BEFORE THE NORTHLAND REGIONAL COUNCIL

Reply Evidence of
Timothy Michael Baker
for the Director-General of Conservation
11 June 2021

REPLY EVIDENCE OF TIMOTHY MICHAEL BAKER

Appendix 1 - Shallow Monitoring Map

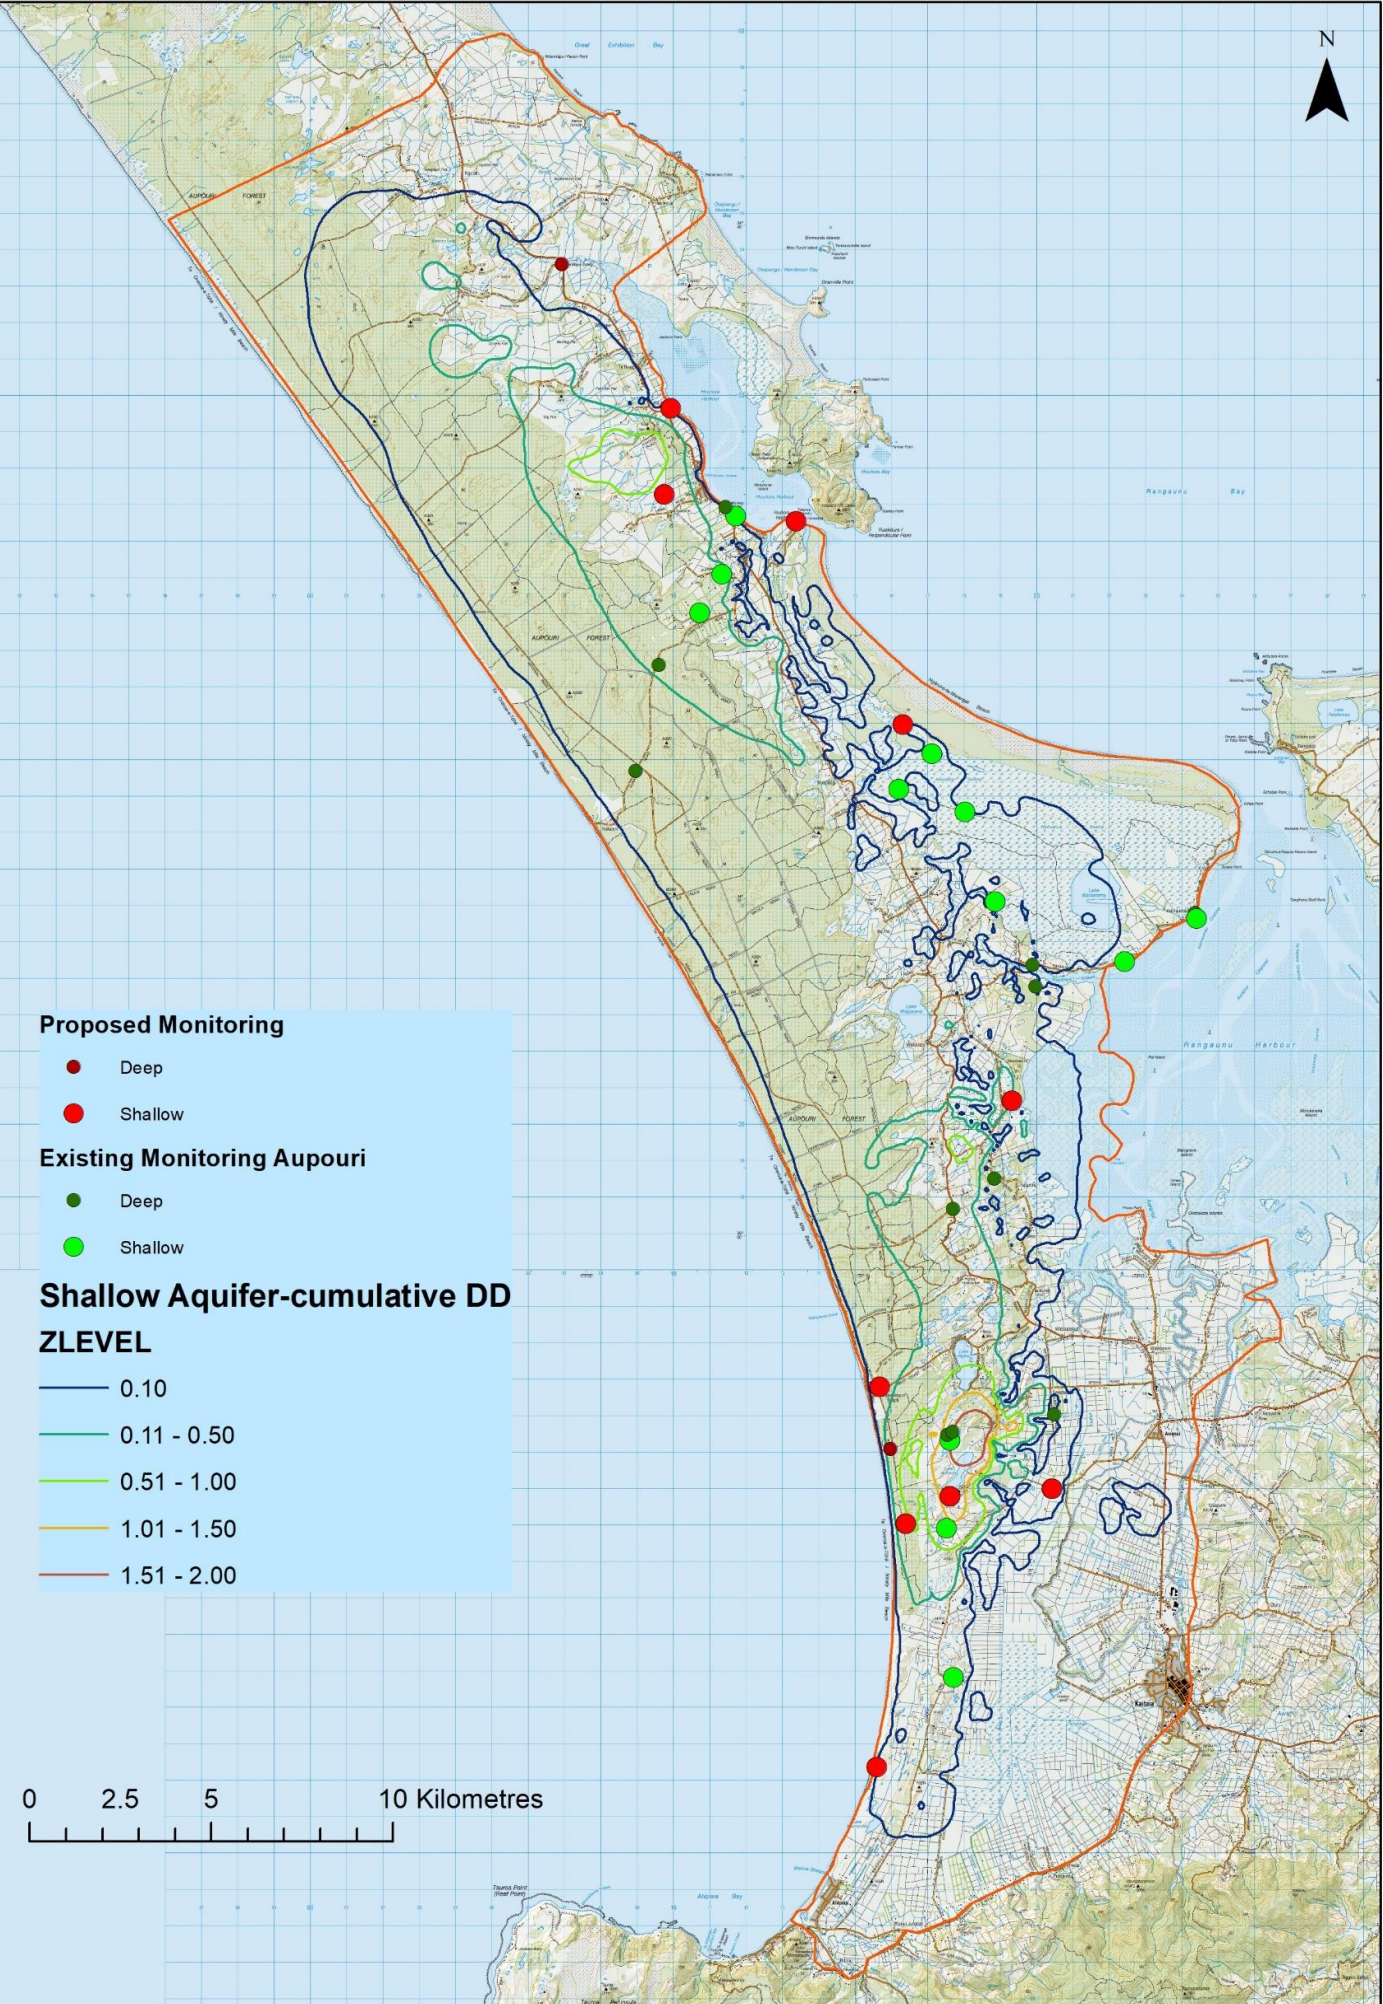
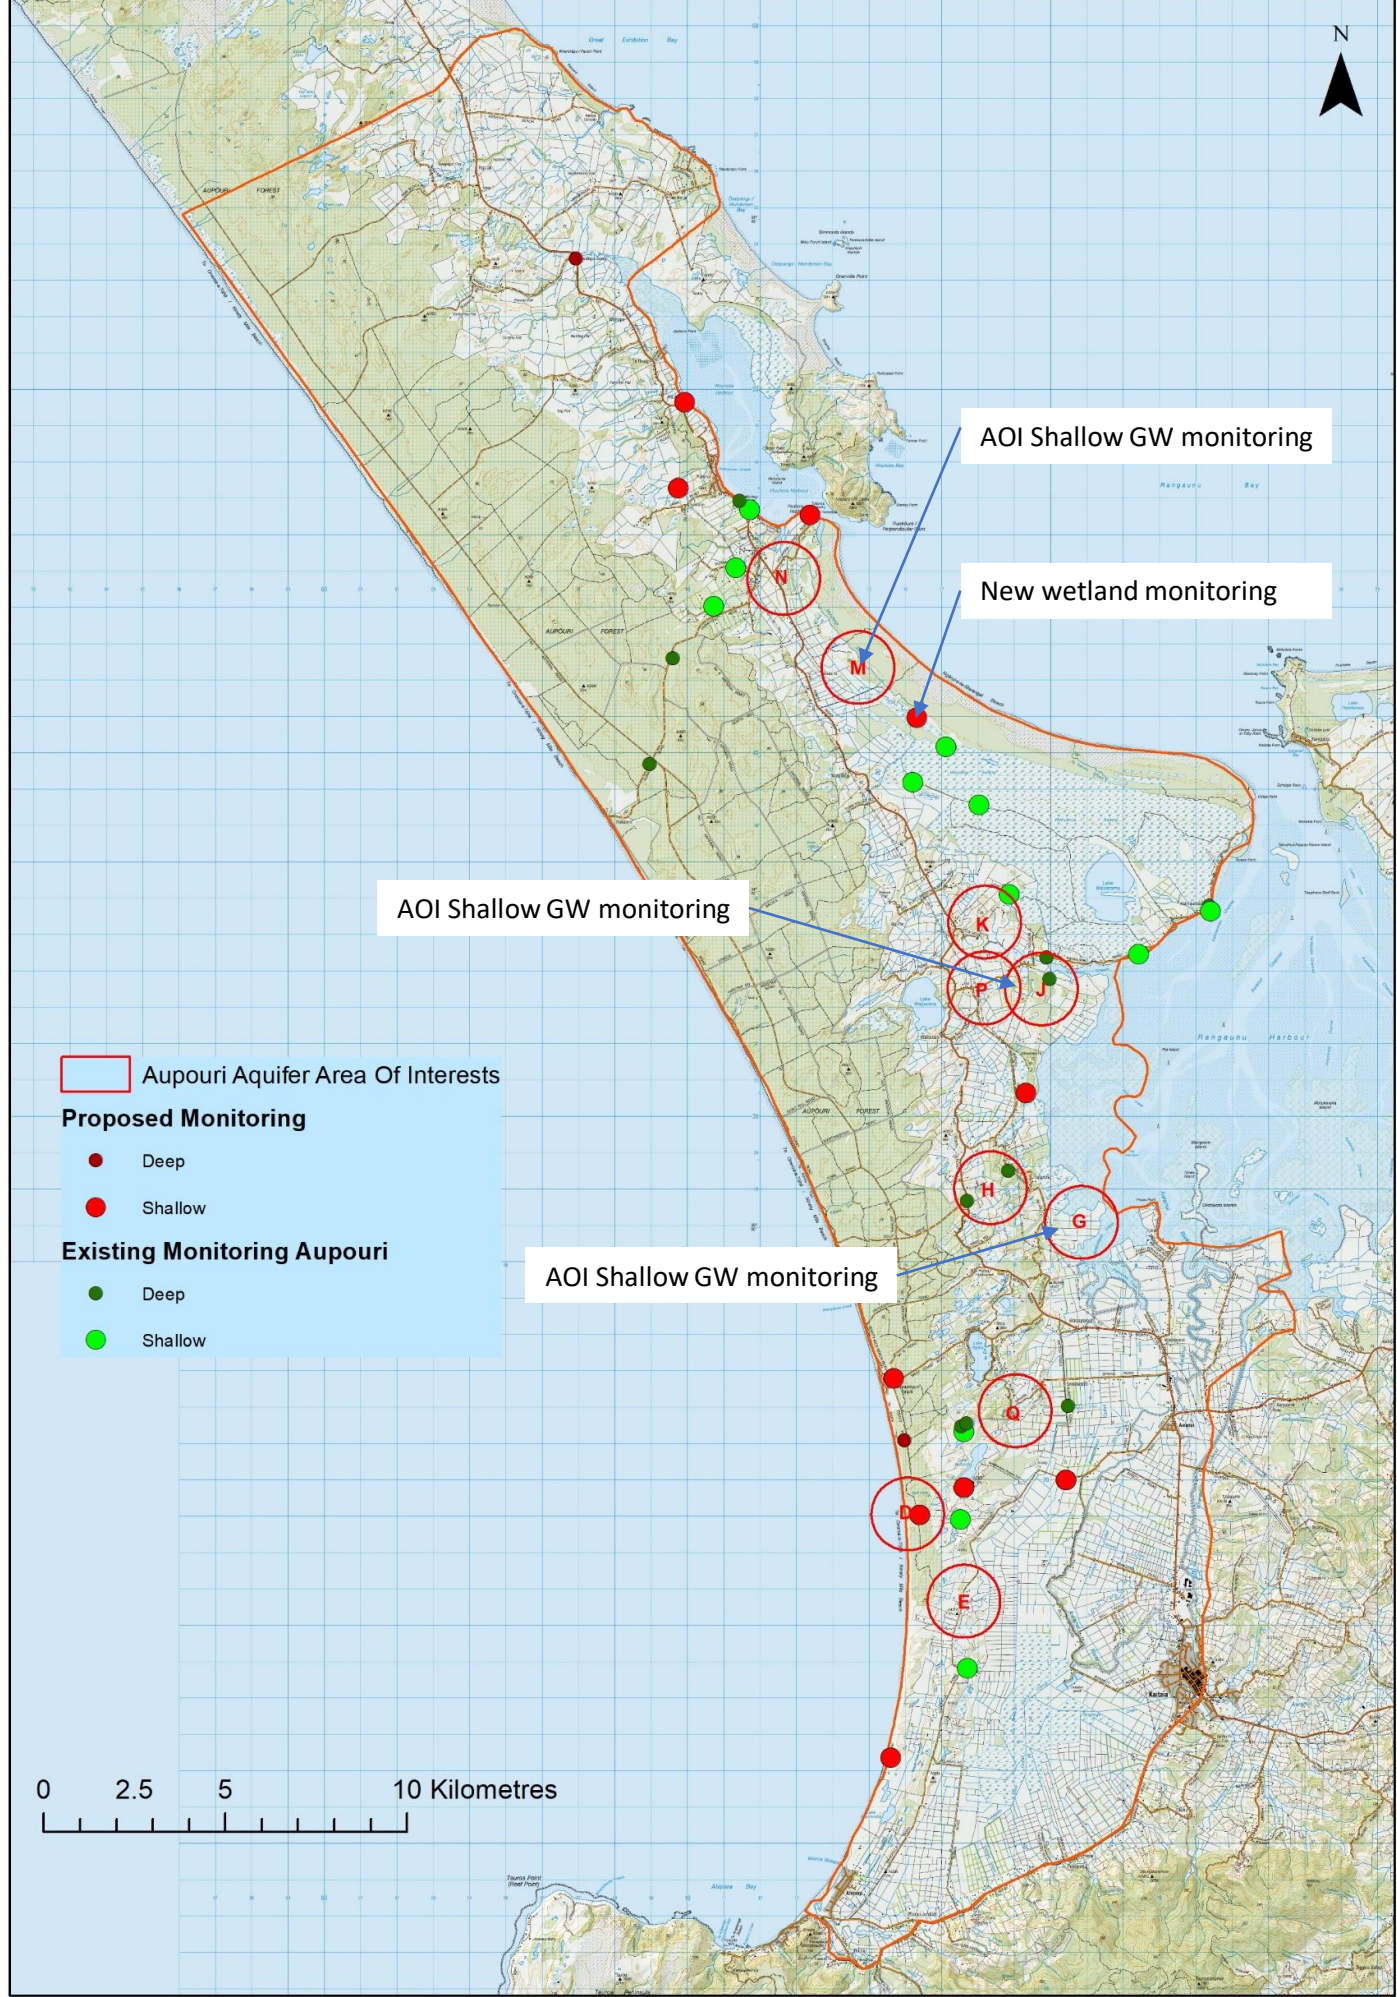
- 37 Additionally, each AOI remaining in the monitoring programme should have an unconfined aquifer monitoring well located close by. I have reviewed the locations of the AOI and the proposed monitoring locations as shown in the GMCPs and recommend the following shallow monitoring well additions:

- a. A shallow unconfined monitoring well in the vicinity of AOI 'M'. This currently appears to be reliant on monitoring of the Motutangi Shallow well that is located ~3 km south of the AOI. The AOI is immediately adjacent to Production Well Bryan Estate-2.

- b. A shallow unconfined monitoring well between AOI 'P' and AOI 'J' because there is no current shallow aquifer monitoring well in the immediate area.

- c. A shallow unconfined monitoring well adjacent to AOI 'G' because this site is isolated from others and there is no current shallow aquifer monitoring well in the immediate area.

- 38 I have Appended a Map (Appendix 1) to this evidence showing the current and proposed shallow groundwater level monitoring, overlaid with the drawdown contours and the additional wells recommended above.
